Fast-track Consent Application

FTAA-2603-1181

Mount Welcome, Pukerua Bay, Porirua

Planning Report on behalf of Porirua City Council

Figure 5: Summary of urban design review recommendations for improvements

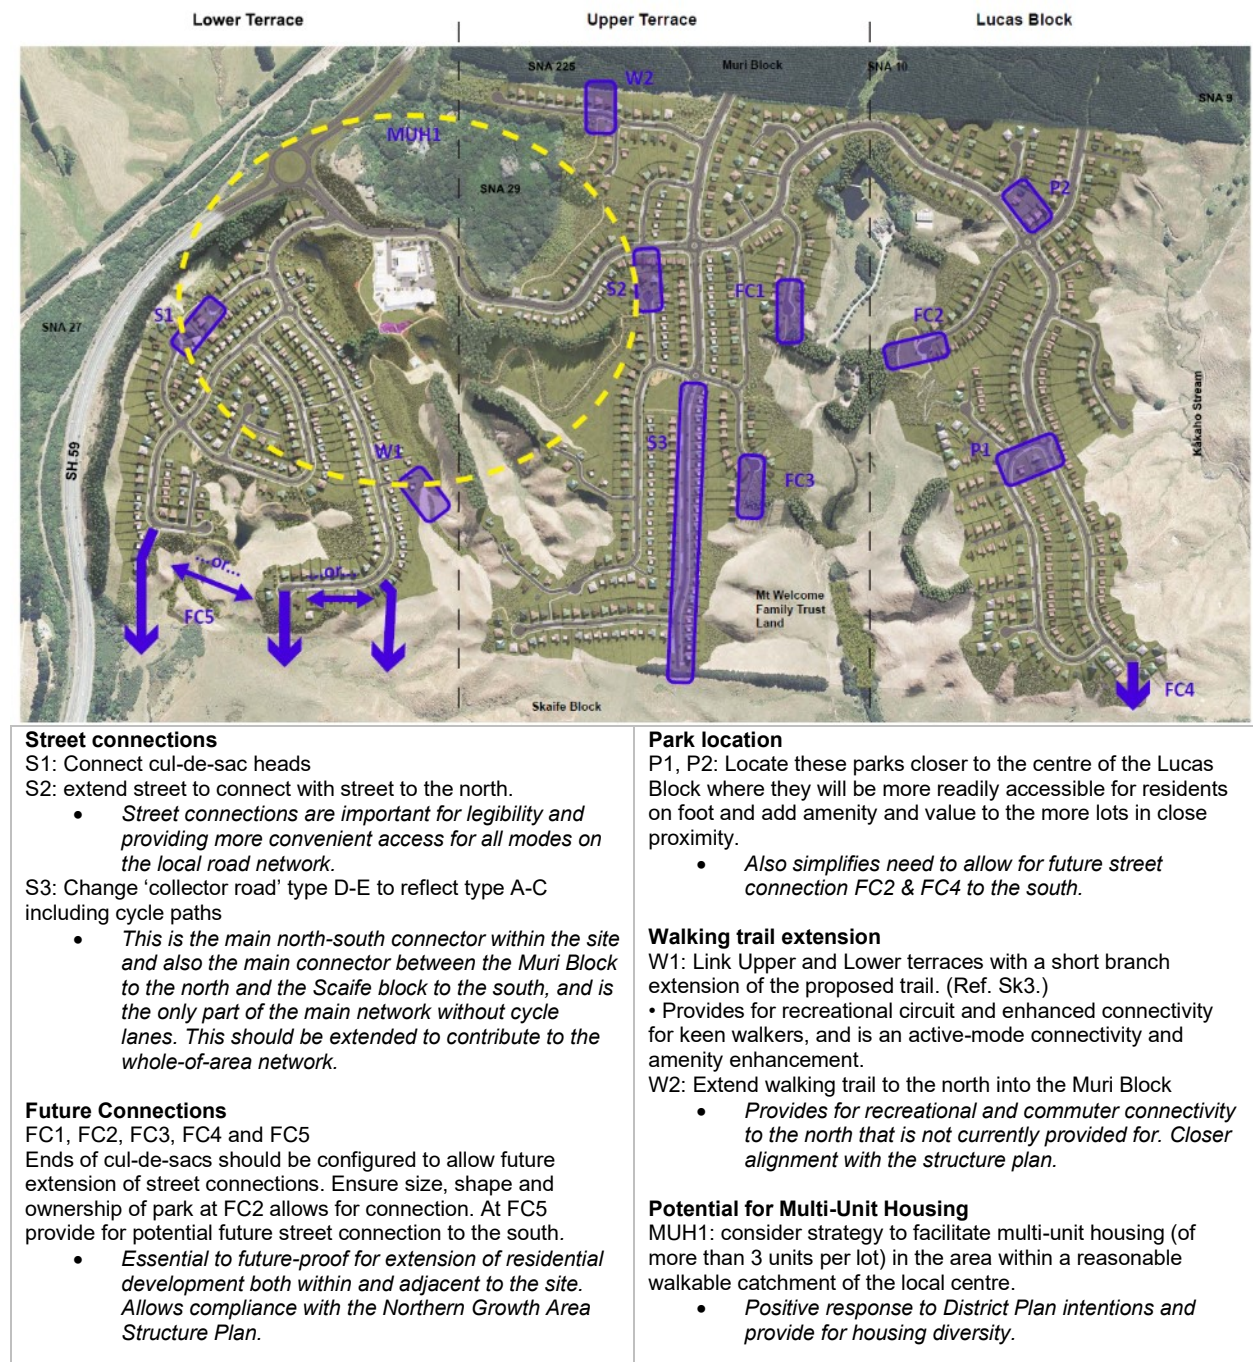
Improvements to the urban design outcomes of the proposed development are set out in the appendix to the urban design review memorandum. These are summarised in Figure 5 below.

Figure 7: Ecological Overlay provided with the application and approximate locations of Structure Plan Transport Connections

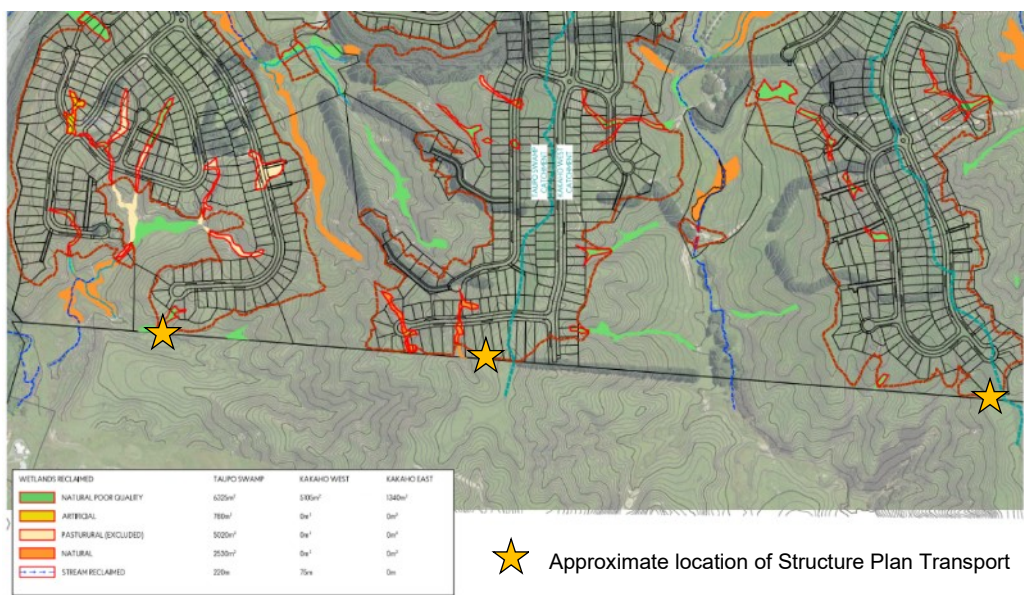
The NGDA Structure Plan (see Figure 4) identifies three ‘Transport connections’ along the southern boundary. The application has provided for one roading connection to the southern boundary, in the general vicinity of the middle connection point (approximately 120 metres east of the location identified on the Structure Plan). The western and eastern Transport Connection points are precluded by the subdivision design which does not allow for a future connection to be created to the proposed roads that terminate close to those Transport Connection points.

In my view, it is critical that the subdivision design allows for the transport connections along the southern boundary to be made in the future. The Council has previously identified this as a critical issue throughout pre-lodgement consultation with the Applicant. Construction of the roads to the boundary is not necessarily required, but rather that the subdivision design should not preclude this for occurring in the future.

The Structure Plan identifies a Transport Connection on the southern boundary approximately 950 metres from the eastern corner of the site. This is in close proximity to the end of Road 26, as shown on Figure 7 above. I note that the proposed earthworks extent (shown in Figure 7 as the red outline) almost extends to the boundary in this location. The proposal includes a park at the end of Road 26. Between the park and the southern boundary is a strip of land that would be part of proposed Lot 5003. There are no wetlands or streams identified on the Ecological Overlay within the site between the end of Road 26 and the boundary of the site.

The Structure Plan identifies a Transport Connection on the southern boundary approximately 230 metres from the western corner of the site. This is in close proximity to the end of Road 10, as shown on Figure 7 above. The proposed earthworks extent almost extends to the boundary in this location. There is a natural wetland identified on the Ecological Overlay in this location; however, it is categorised as 'poor quality' and is already proposed to be reclaimed by the Applicant as it is within the proposed earthworks extent.

Figure 9: Area of eastern connection of future east-west road
 Source: 1753-02-5001-R2-2026-07-02, Drawing 1029

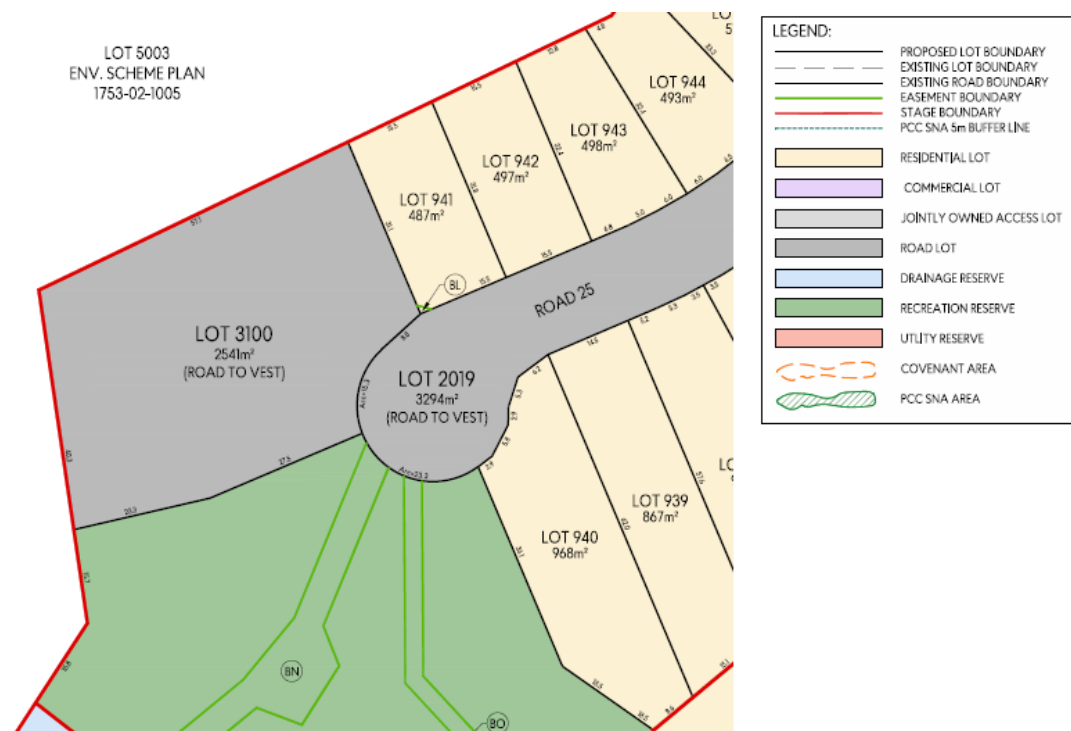
- Eastern connection point:** As shown in Figure 9 below, the area of the eastern connection point of the future east-west road to Road 25 is proposed to be vested with Council partially as a recreation reserve (being lot 1212) and partially as road reserve (being Lot 3100). The area of the recreation reserve adjoins approximately the southern half of the turning head of the cul-de-sac, while the road reserve covers the northern half. No justification is provided for the location of the split between the two classifications, or a potentially feasible roading alignment provided. Without this information, it is not known whether the location of the road reserve is appropriate. As such, in order to enable a roading connection through lot 1212 in the future, the classification of allotment 1212 may need to be changed. The change of a classification of a reserve is controlled under section 24 of the Reserves Act 1977. I consider that this places a significant and unnecessary administrative burden on Council, and any applicant for subdivision of lot 5003, to achieve a roading connection through lot 1212 to Road 25 in the future.

Additionally, I note that the loss of the area of recreational reserve from this location has not been provided for through relocation to another area. As noted above in section 6.3.3.9, in my view, the proposed park at this location should be relocated as recommended in the urban design review.

Figure 10: Area of western connection of future east-west road
Source: 1753-02-5001-R2-2026-07-02, Drawing 1025

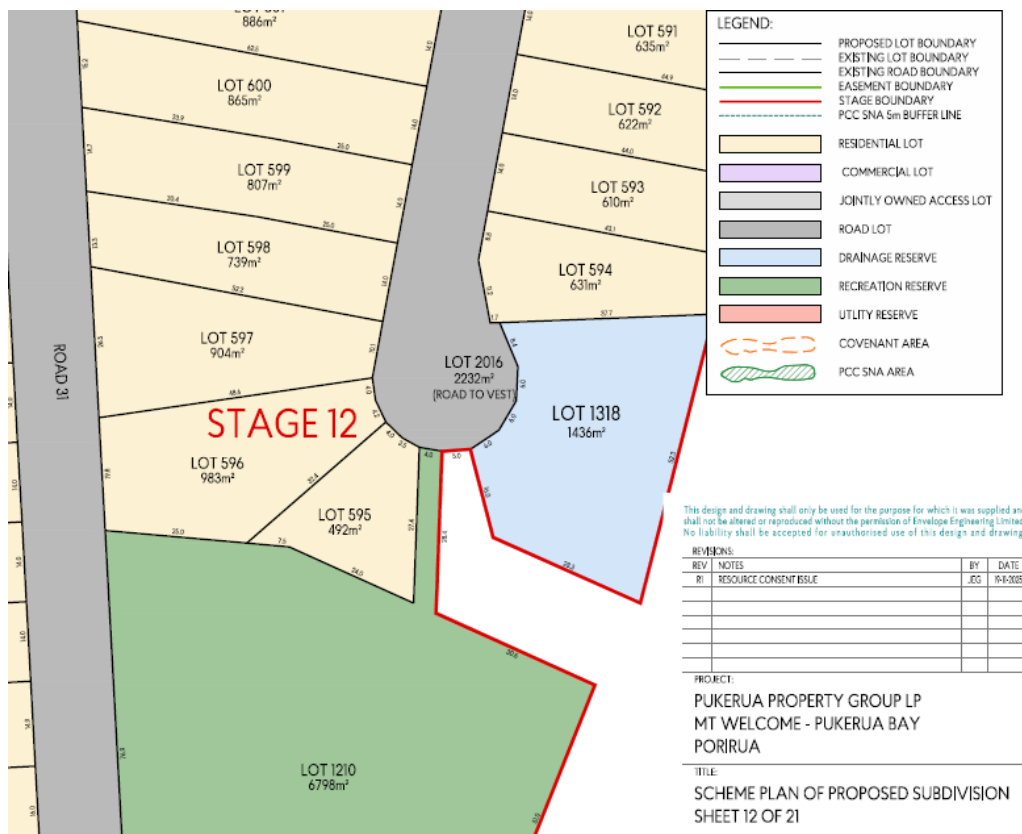
- Western connection point:** As shown in Figure 10 below, the area of the western connection point of the future east-west road to Road 21 is proposed to be only five metres wide. If the adjoining land proposed to be vested as recreation reserve were to be included (which, as addressed above, I consider is not practicable), the width remains narrow at less than nine metres. The Porirua District Plan 2025 requires a legal width of at least 15.2 metres for Access roads servicing up to 2,000 AADT.¹¹

Because of these constraints, and contrary to the assessment provided by the Applicant, I consider that with the existing proposed subdivision design, it is not possible to achieve a future road connection through Lot 5003 to give effect to the Structure Plan. This triggers clause 1 of policy DEV-NG-P4 of the Porirua District Plan 2025, which, under a normal RMA consenting process, would mean that the proposed development would be required to be avoided.

Figure 11: Example of raingarden located within road reserve

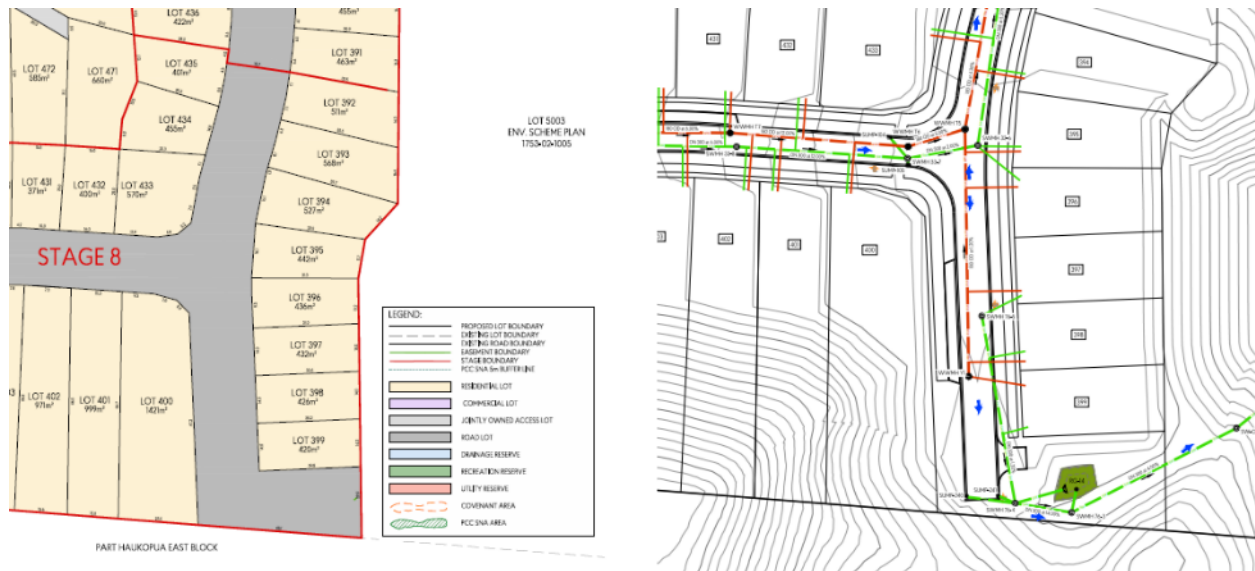
There is three waters infrastructure within allotments identified to be vested as road reserve. An example is the raingarden located at the end of Road 02, as shown in Figure 11 below.

Figure 12: Consent notice areas identified on proposed road to vest
Source: Appendix E – Updated scheme plans 1753-02-1010, Drawing No. 1017.

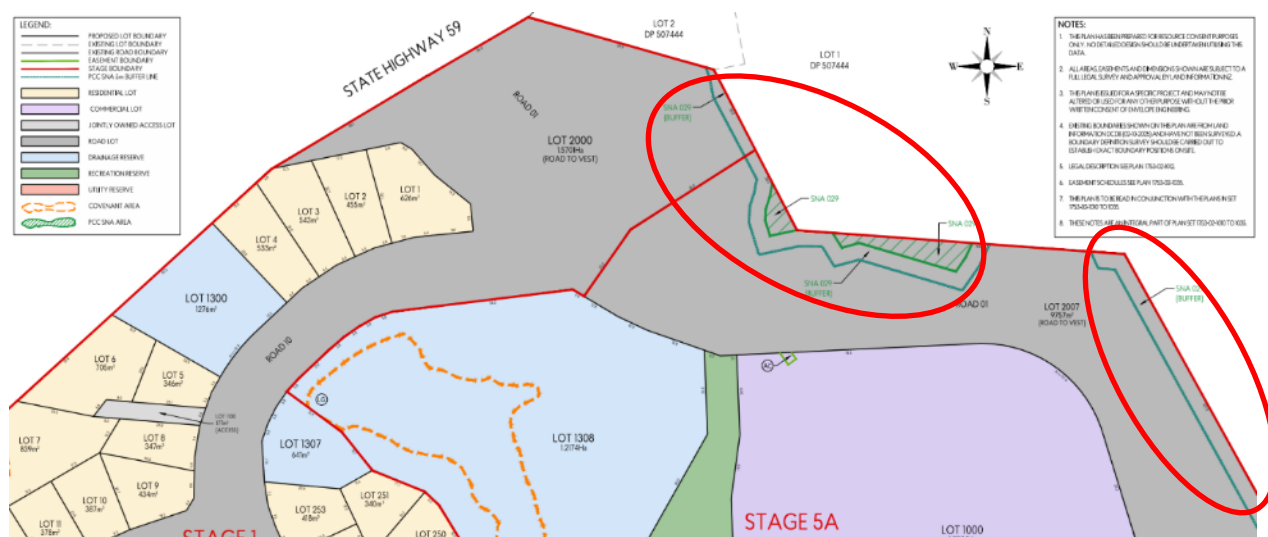
The scheme plan provided with the application identifies consent notice areas within allotments proposed to be vested as road reserve. Examples of this are shown circled in red in Figure 12 below.

Lands parcels vested as roads are not issued a record of title. As such, consent notices cannot be associated with these parcels.

Figure 13: Stream offset area within Lot 5003

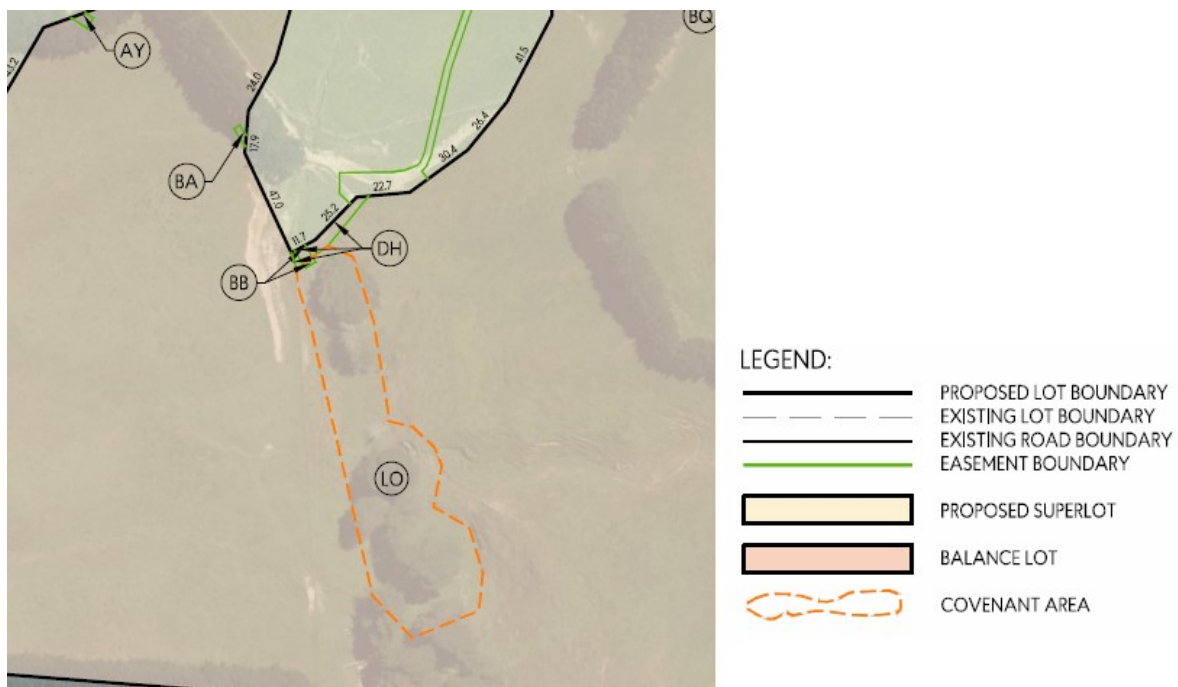
The stream offset area is within Lot 5003, which is proposed to be subdivided as part of the initial 'superlot' subdivision, as discussed in section 6.4.1.1 above. Lot 5003 is proposed to be retained by the current owner with the existing farming land uses to continue. An extract of the proposed subdivision scheme plan is shown in Figure 13 below. The area identified as 'LO' is proposed to be subject to a 'land covenant' as described in the subdivision schedules.

There is a disconnect between the scheme plan, which refers only to 'covenant area' on the plans or 'land covenant' in the schedule, and the proposed conditions which refer specifically to 'Conservation Covenant Areas identified on the Scheme Plan' (see proposed condition 103). This is discussed further in section 7 below.

The applicant responded to comments from Porirua City on the first substantive application relating to the need for access to the stream offset area in the Lot 5003. The response was to provide an easement area from the 'retention wetland' area, identified as Stage 20 on the proposed scheme plan, to the stream offset conservation covenant area. This easement area is identified as DH in Figure 13 below.

Figure 16: Location of proposed wastewater storage facility

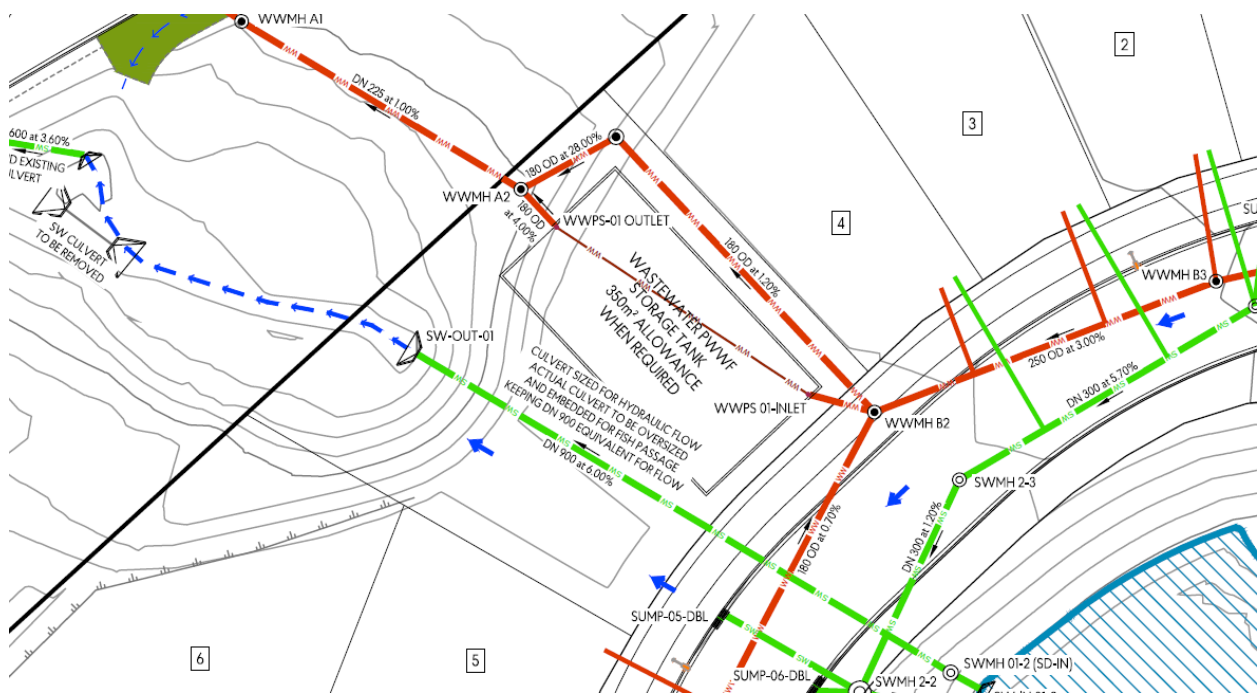
The proposed wastewater and stormwater network in the vicinity of Lot 1300 is shown on the plan identified as 'Appendix 30-24 – 1753-02-4100-R1-Drainage-Detailed'. An extract of drawing 4101 is provided in Figure 16 below. Additionally, the long section of the wastewater infrastructure on Lot 1300 is shown on drawing 4400 in '1753-02-4400-R2-Drainage-WW-Longsections' contained in Appendix 30-27 of the application. The long-section identifies the storage as being located below ground level, with a maximum depth of approximately 5.4 metres below ground level.

Additionally, the allotment where the storage facility is proposed is constrained because of the proposed wastewater and stormwater pipework and overland flow path proposed to be located on the allotment as shown in Figure 16 above. I note that the wastewater pipe along the northeast boundary of the allotment would need to be installed as part of Stage 1, while the stormwater pipe which bisects the allotment is proposed to convey discharges from the 'retention wetland' to the southeast which is identified as part of Stage 5A.

Figure 17: Helicopter hanger proposed to be within Lot 5003
Source: Drawing 1013, Updated Scheme Plan 1753-02-1010-R3

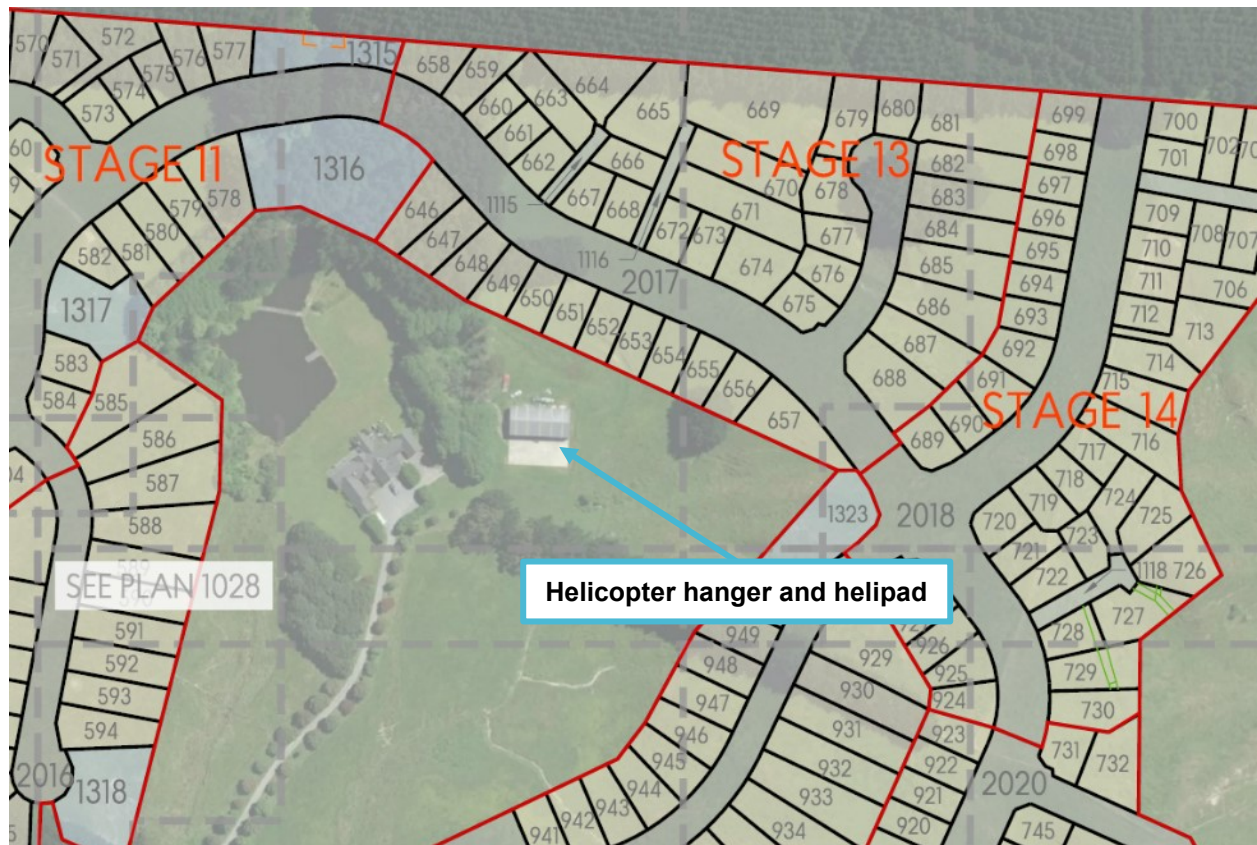
This hanger and helipad are proposed to be contained within Lot 5003, which is to be retained by the existing owner. Existing farming activities within Lot 5003 are stated in the application as to be continued. Presumably, the existing activities that are proposed to continue include the activities relating to the hanger and helipad.

Photographs of the hanger are provided in Appendix E of the PSI (photographs 10 and 11). The hanger is located approximately 25 metres from proposed lot 652. An aerial photograph overlaid with the proposed subdivision scheme plan in the vicinity of the helicopter hanger is provided in Figure 17 below.

If the helicopter hanger and helipad is a legally established activity, the location of the proposed new residential allotments may result in reverse sensitivity effects that have not been addressed through the proposed development. Conversely, if the hanger and helipad and associated uses have not been legally established, then the continuation of activities relating to the hanger and helipad would likely have adverse noise effects on the new residential allotments. In my view, clear information about the continued use of the helipad and hanger, as well as potentially additional conditions are required to address this issue in either case.
